SERVICE BULLETIN

No. 331

Piper Aircraft Corporation

Subject: Electric Trim Switch Inspection and Modification

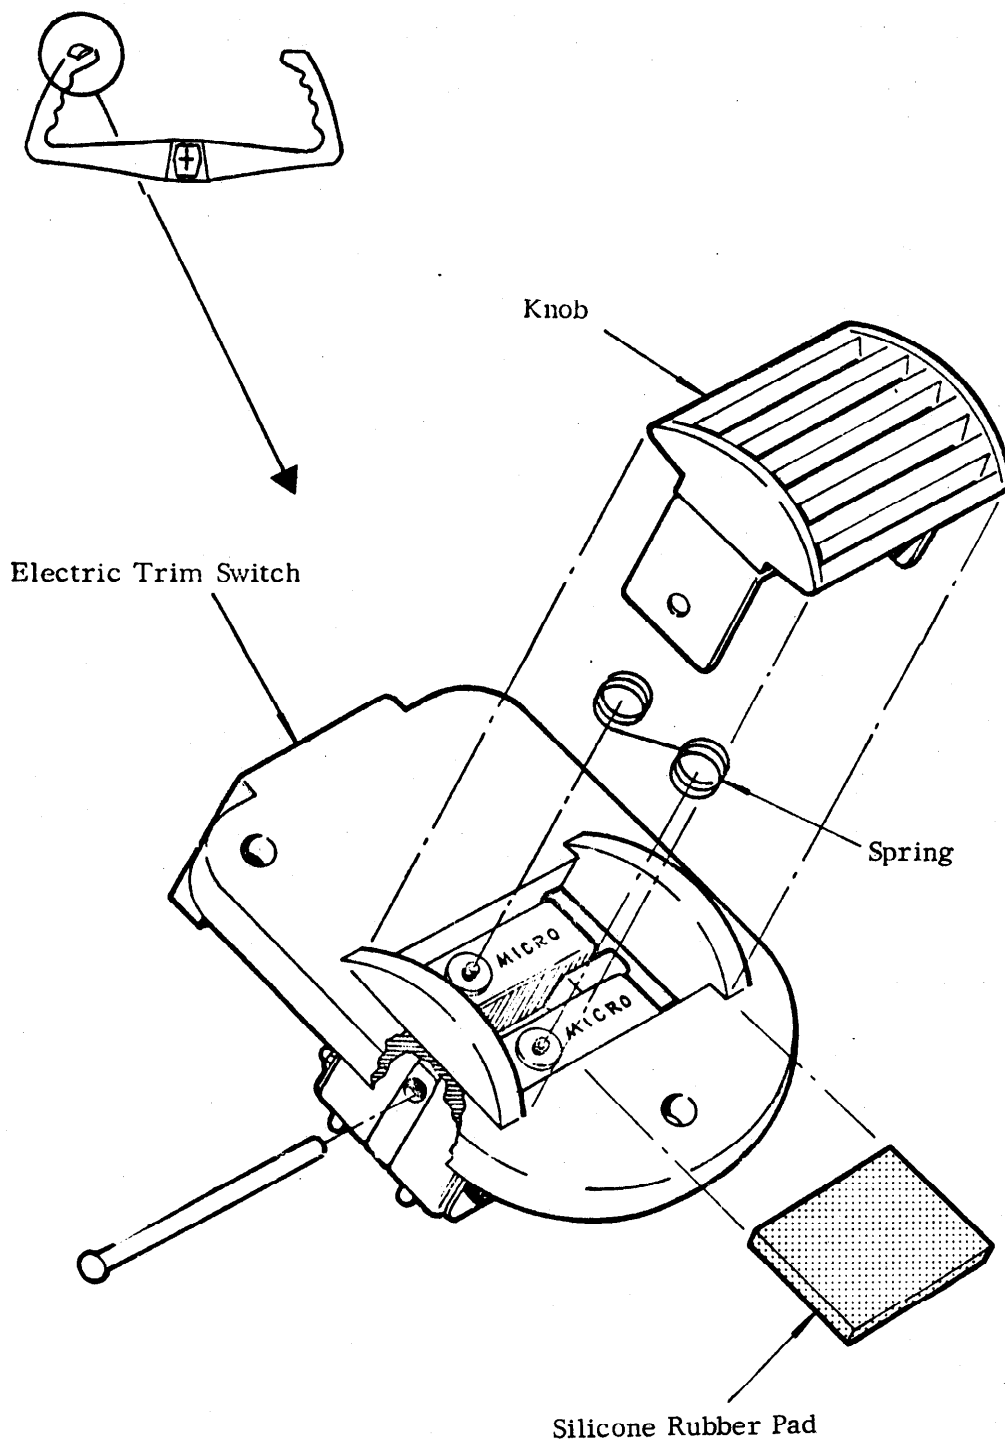
To modify the pilot's control wheel mounted "rocker" type trim switch by replacing the existing neutral return device (silicone rubber pad) with a coil spring (reference sketch on page 4 for a general description).

2. If the existing trim switch operates properly, the switch should be modified per the material and instructions (contained in Kit No. 760 505, Electric Trim Switch Modification). This may be accomplished as specified in Compliance Time II, above.
